**Subject: Docket Nos. 50-361 and 50-362
Proposed Technical Specification Change Number NPF-10/15-516
Reduce the Minimum Boltup Temperature for Reactor Vessel Head
Bolts When They Are Tensioned
San Onofre Nuclear Generating Station Units 2 and 3**

AMENDMENT APPLICATIONS 199 AND 184

(PCN-516)

**DESCRIPTION AND SAFETY ANALYSIS
OF PROPOSED CHANGES NPF-10-516 and NPF-15-516**

FIGURE 3.4.3-4

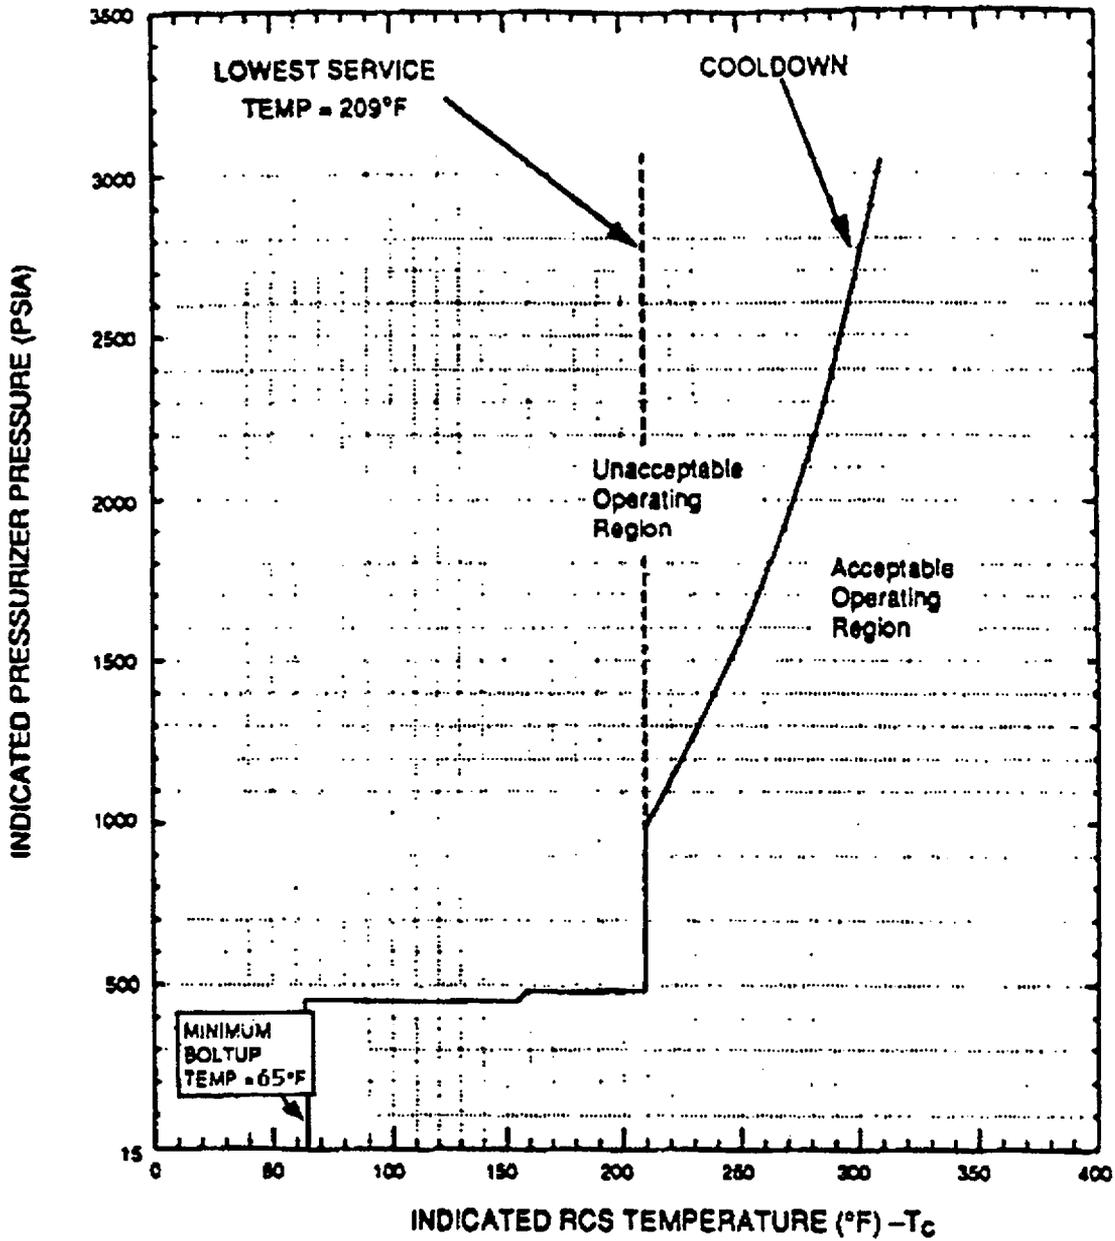
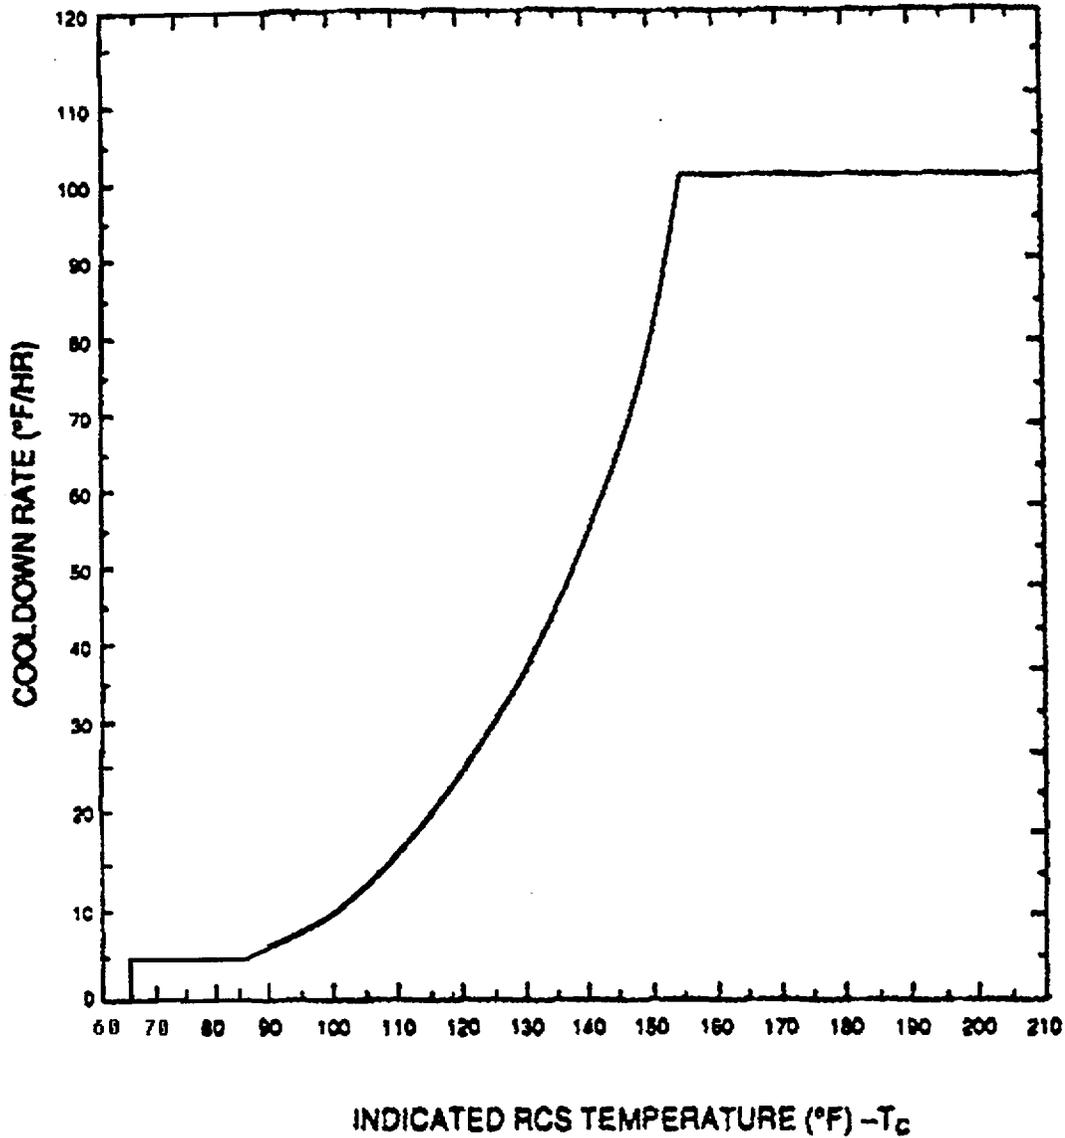
LCO Conditions "a" and "d", a footnote at page 3.4-5 and Figures 3.4.3-1 through 3.4.3-5 will be revised to reflect this new value. The Pressure-Temperature curves on Figures 3.4.3-1 through 3.4.3-5 will be extended from 86°F to 65°F. During operation at temperatures between 86°F and 65°F, the pressure limit change is negligible. Additionally, the TS bases will be updated to reflect the basis for the MBT of 65°F.
